OTIF/RID/CE/2011/9

**RID: 50th Session of the Committee of Experts on the Transport of Dangerous Goods
(Malmö, 21 – 25 November 2011)**

**Subject: Consolidated amendments adopted by the RID/ADR/ADN Joint Meeting in 2010
and 2011 and by the RID Committee of Experts Meeting in 2009 and 2010**

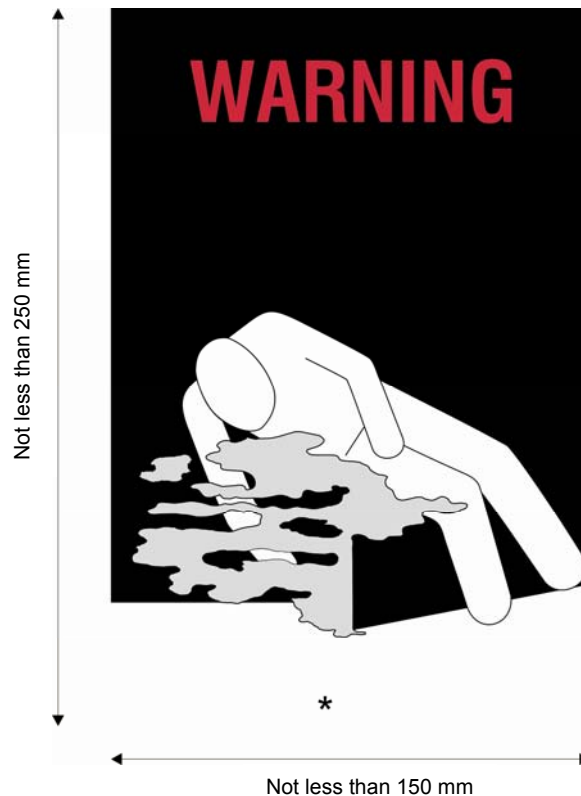
- (a) The word "WARNING" in red or white with lettering not less than 25 mm high in an official language of the country of origin and also, if that language is not English, French, German or Italian, in English, French, German or Italian, unless agreements concluded between the countries concerned in the transport operation provide otherwise; and
- (b) The name indicated in Column (2) of Table A of Chapter 3.2 followed by the words "AS COOLANT" or "AS CONDITIONER" as appropriate, shown below the symbol in black letters on a white background with lettering not less than 25 mm high in an official language of the country of origin and also, if that language is not English, French, German or Italian, in English, French, German or Italian, unless agreements concluded between the countries concerned in the transport operation provide otherwise.

For example: "CARBON DIOXIDE, SOLID, AS COOLANT".

An illustration of this mark is given below.

* Insert the name indicated in Column (2) of Table A of Chapter 3.2 followed by the words "AS COOLANT" or "AS CONDITIONER" as appropriate.
